ECE/TRANS/WP.29/2007/24
5 April 2007

Proposal for Supplement 9 to the 04 series of amendments to Regulation No. 16
(Safety-belt anchorages)

Submitted by the Working Party on Passive Safety (GRSP)

"Annex 8

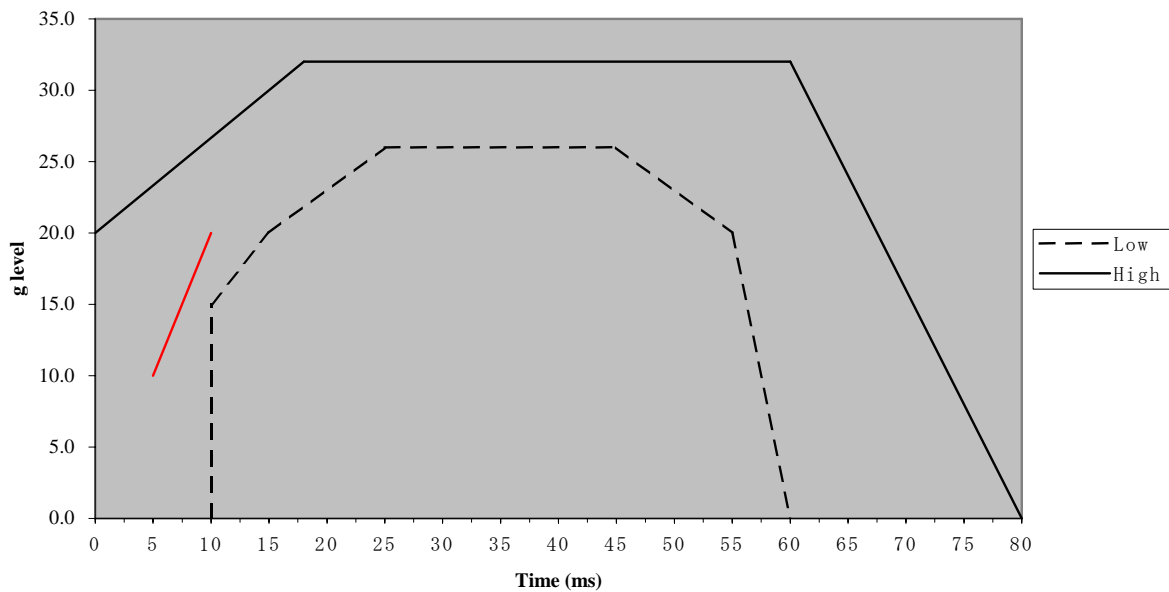
Annex 8, amend to read:

DESCRIPTION OF THE CURVE OF TROLLEY'S DECELERATION OR ACCELERATION,
AS A FUNCTION OF TIME

The additional segment (see paragraph 7.7.4.2.) applies only for the acceleration sled "

The acceleration curve of the trolley, weighted with inert mass, must remain within the hatched area of the graph in Annex 8, and stay above the segment defined by the coordinates $10g, 5 \text{ ms}$ and $20g, 10 \text{ ms}$. The start of the impact (T_0) is defined, according to ISO 17 373 (2005) for a level of acceleration of $0.5g$. In no case shall the total mass of the trolley and vehicle structure and inert masses differ from the
